DEVELOPMENT REVIEW BOARD
SUPPLEMENTAL SUBMITTAL

PROJECT NO. PR-2021-004038
Application No. SD-2021-00098

A Lot Consolidation Replat, combining Lots 3, 4, 5, & 6, Block 8, Broadacres Subdivision at the northwest corner of Menaul & Pennsylvania

June 4TH, 2021

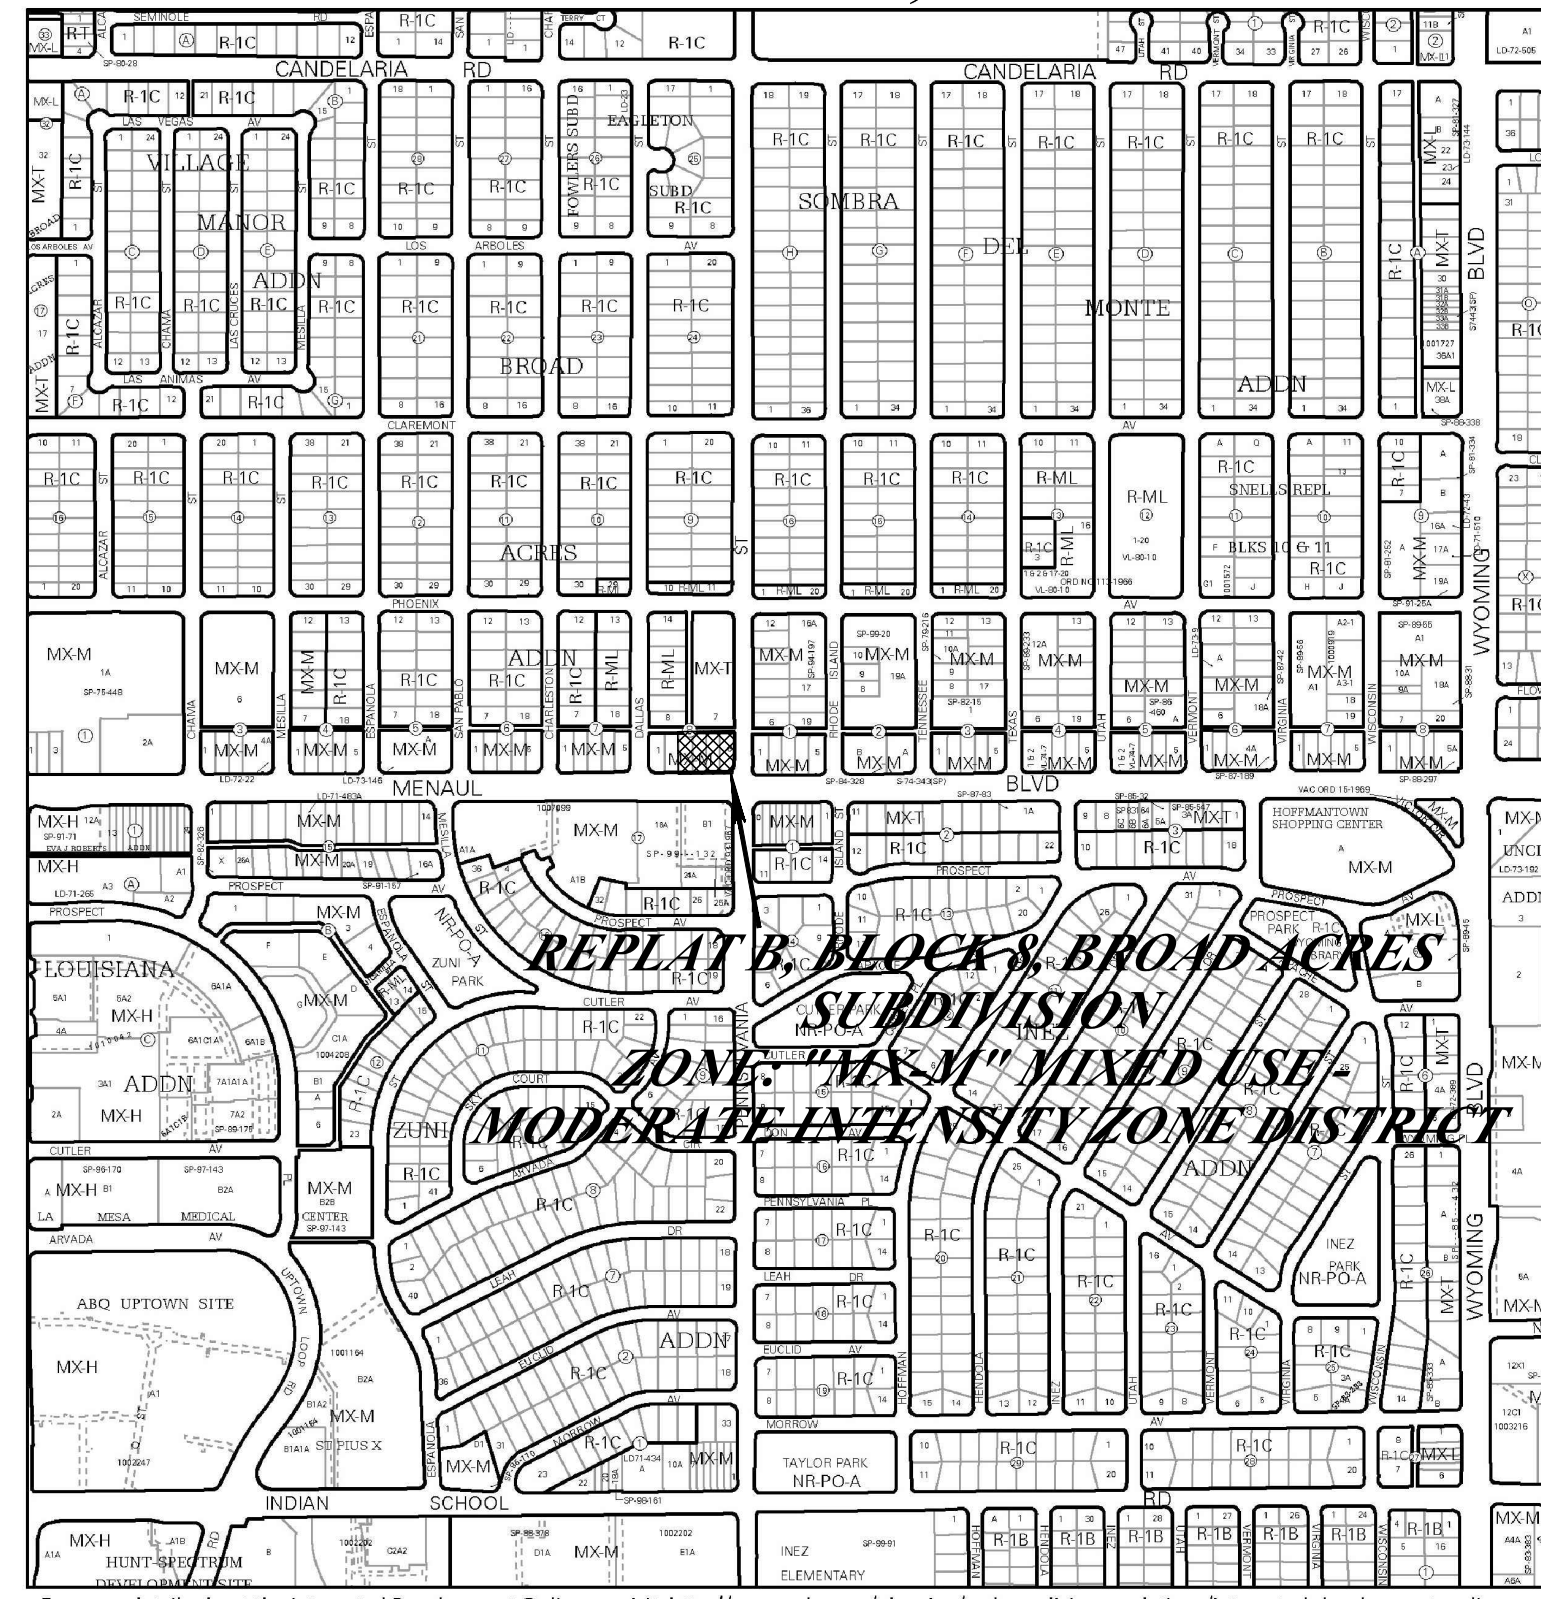
1. Provide radius at property corners at the street intersections. Take clear sight distances into account as well as making sure all public infrastructure is within right-of-way.

Response: 25' radius added to R/W at northeast and southeast property corners, being road and alley intersections. This will allow for clear sight distance for cars and pedestrians at these intersections.

Design: RJM	Proj: 19.106
Draw: JMM	Dwg: 19-106.dwg
Check: RJM	Tab: C2.2-SP
Scale: 1" = 20'	
Date: 02.05.2021	
Sheet: SITE PLAN	
Sheet No.: C-2.2

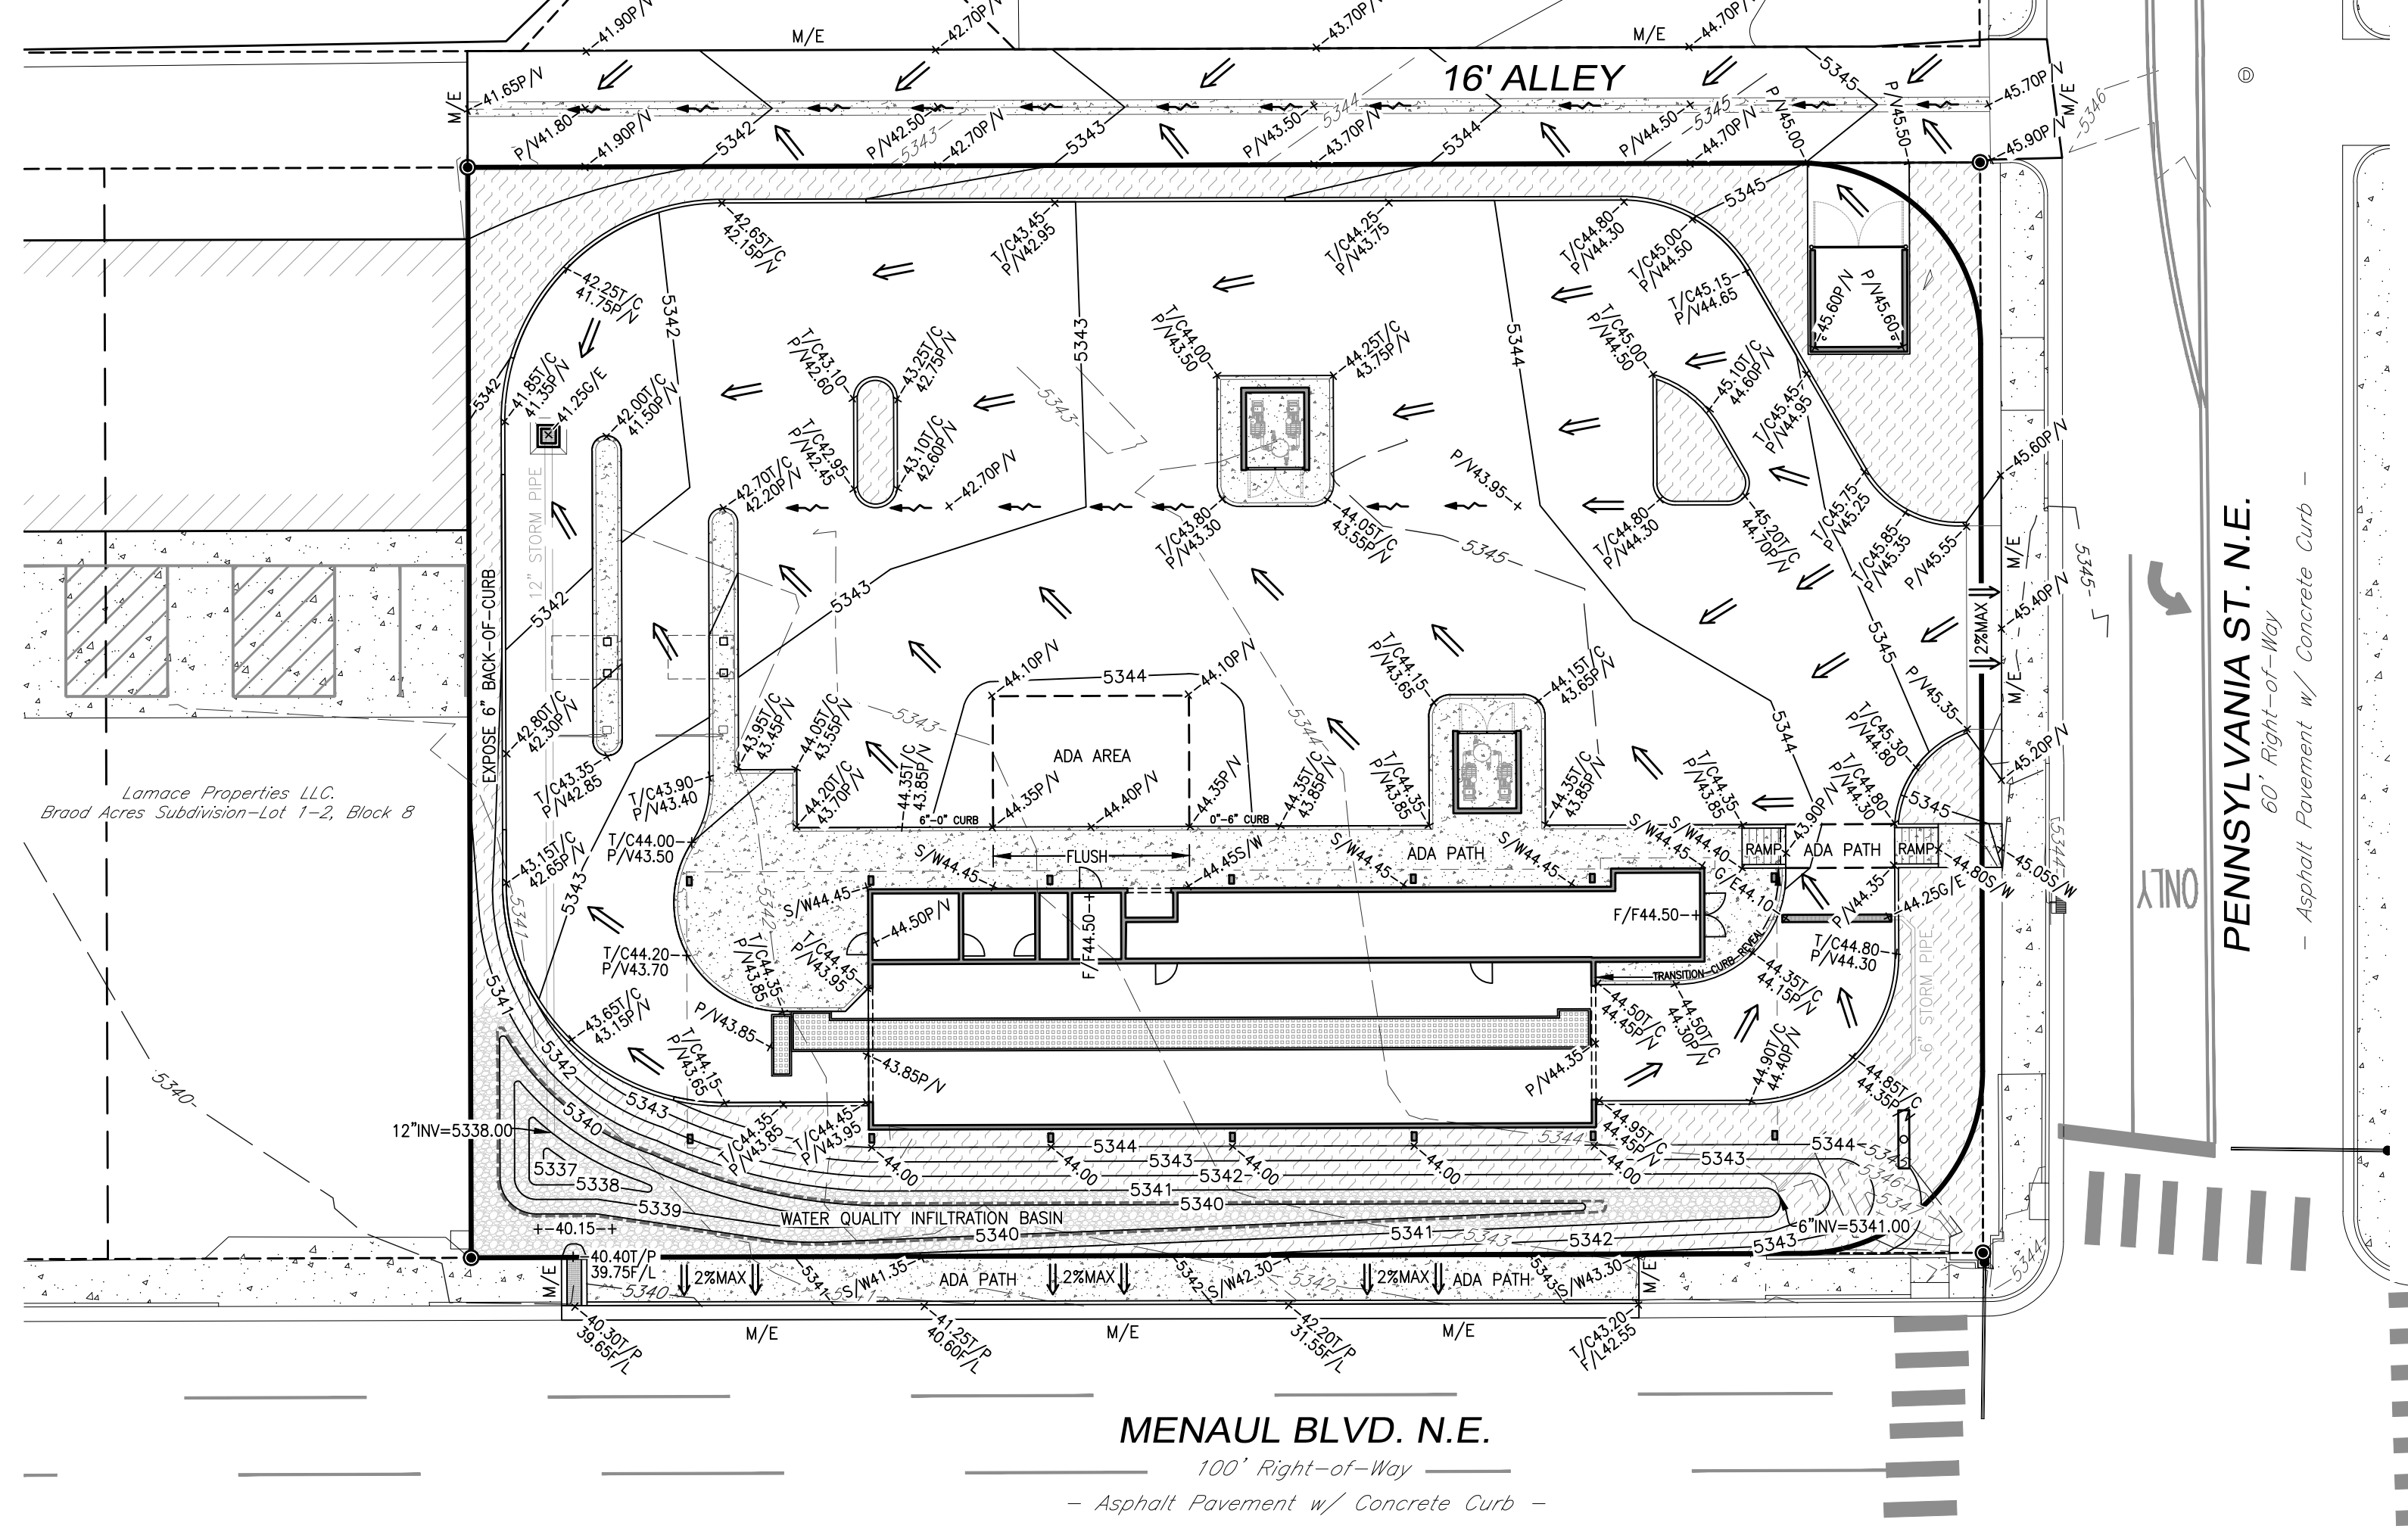
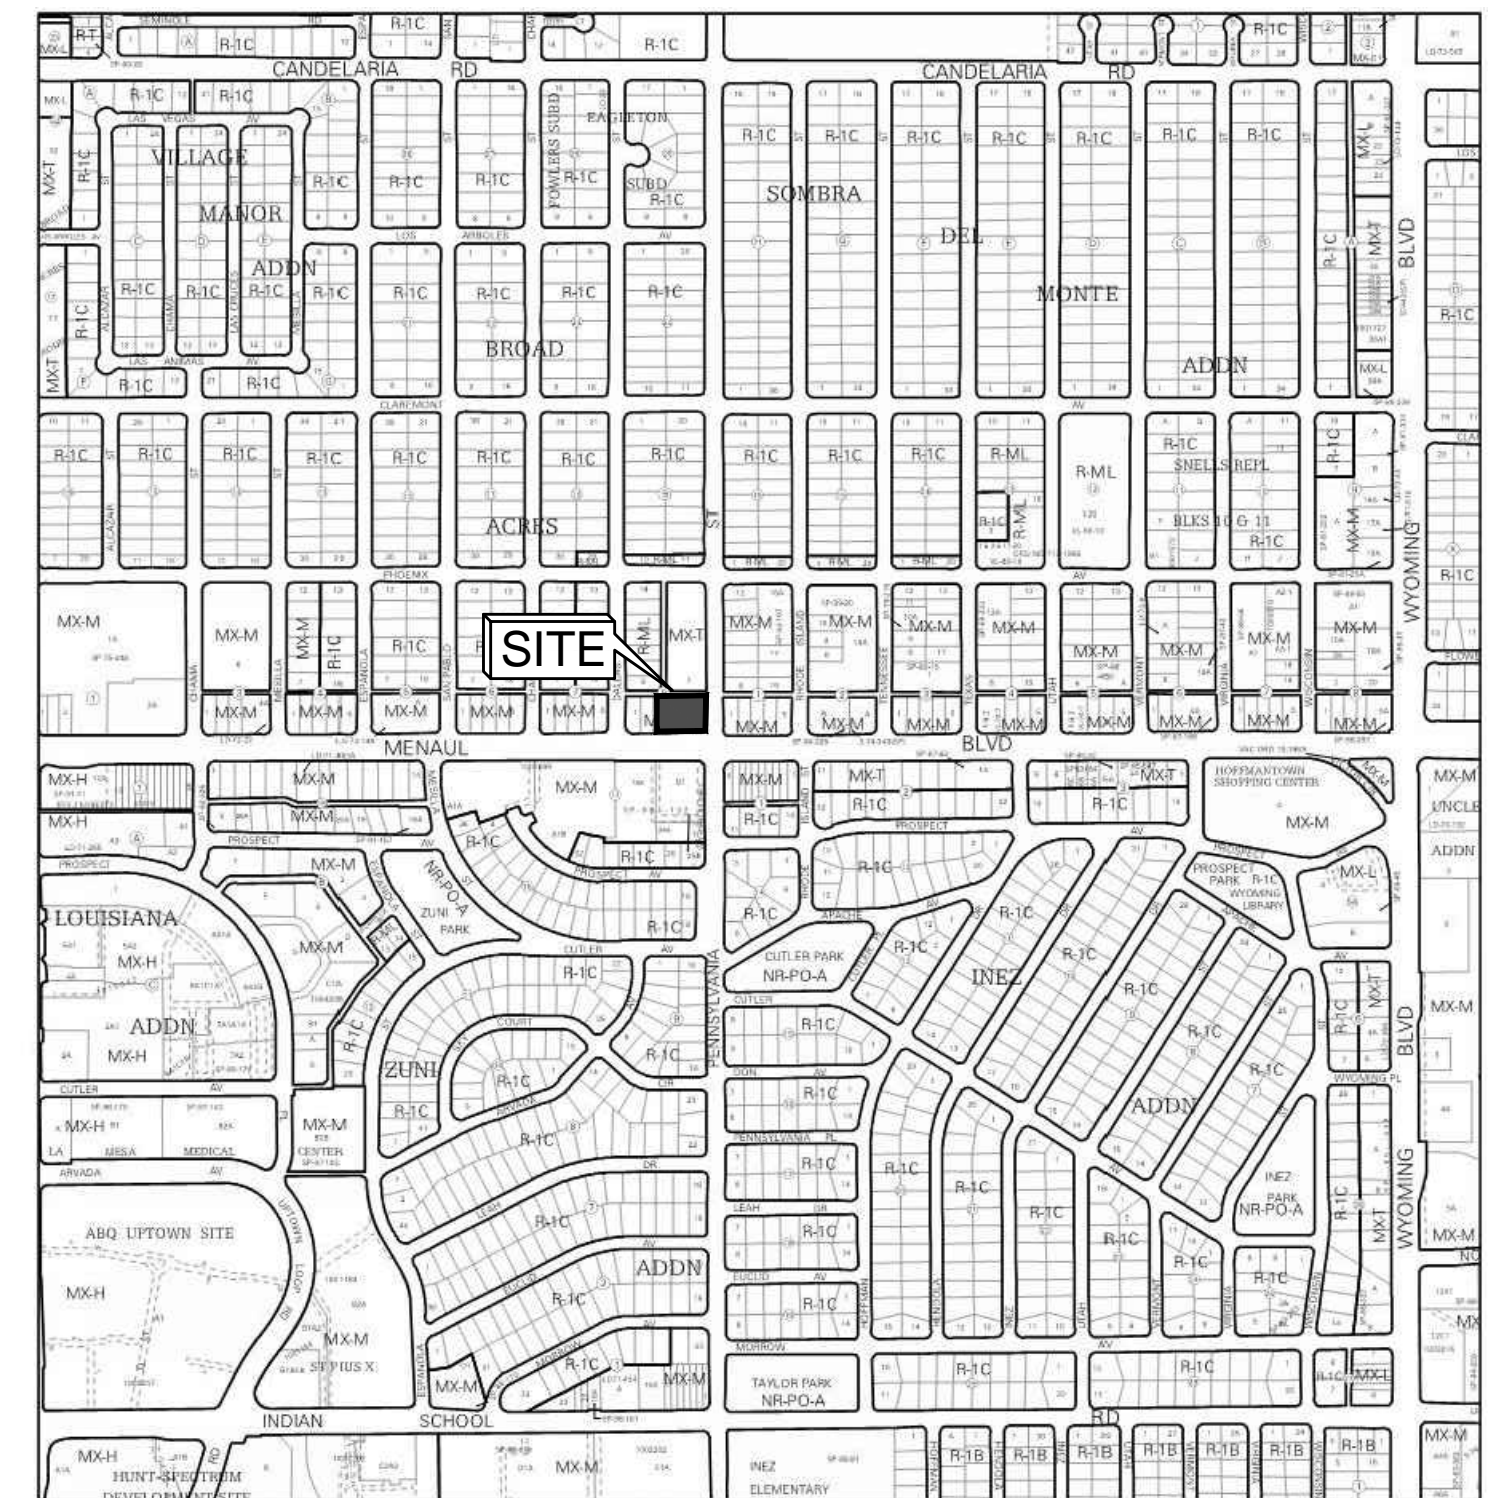
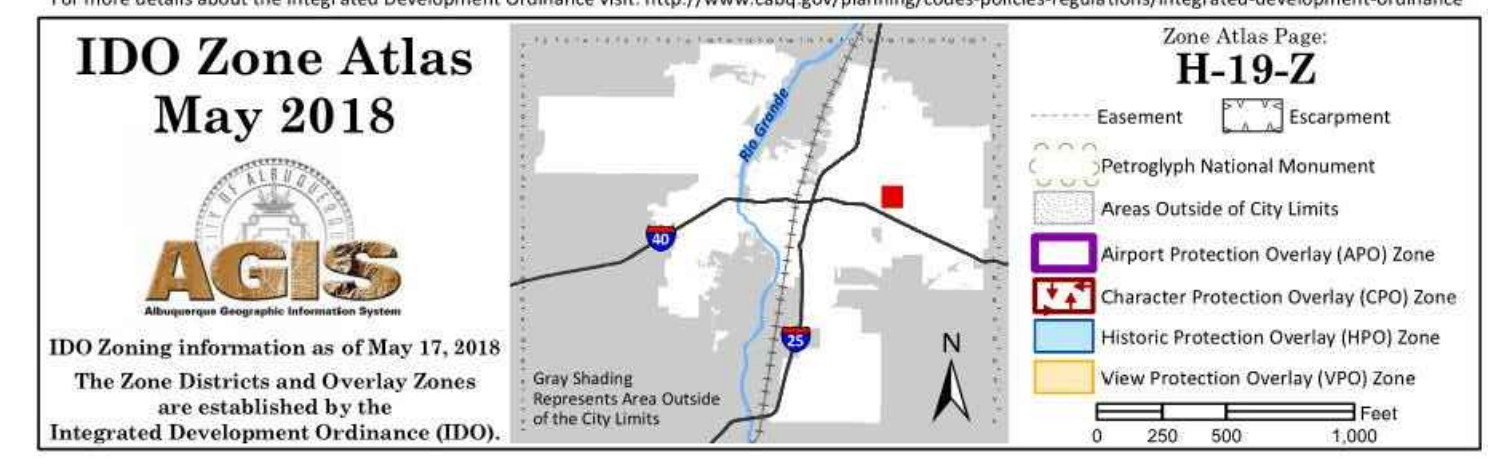
- Hydrology has no objection to the platting action.
Response: No Plat changes requested per drainage review.
- Comment – Site Plan – It appears that there is inadequate room for a trash truck to do a 90 degree turn in the alley between the two existing power poles. Please verify with Transportation on this issue. The trash enclosure may have to be rotated at a 45 degree to the alley instead for easy use. If this does get changed, then an updated Grading & Drainage Plan will be needed to submit to Hydrology. See photo below.

Response: See response to Traffic Comment #4.
- Since the existing alley is in poor condition and that this site plans to use this and even place a concrete pad within the Public Alley, the entire alley along the northern property line will need to be brought to current City standards per drawing #2411.

Response: Plans updated to show alley reconstruction to 16’ Portland cement concrete per City Standard Paving Detail #2411. See sheet C-2.2 (Site Plan) for pavement installation details. (reduced 8.5”x11” attached for reference)
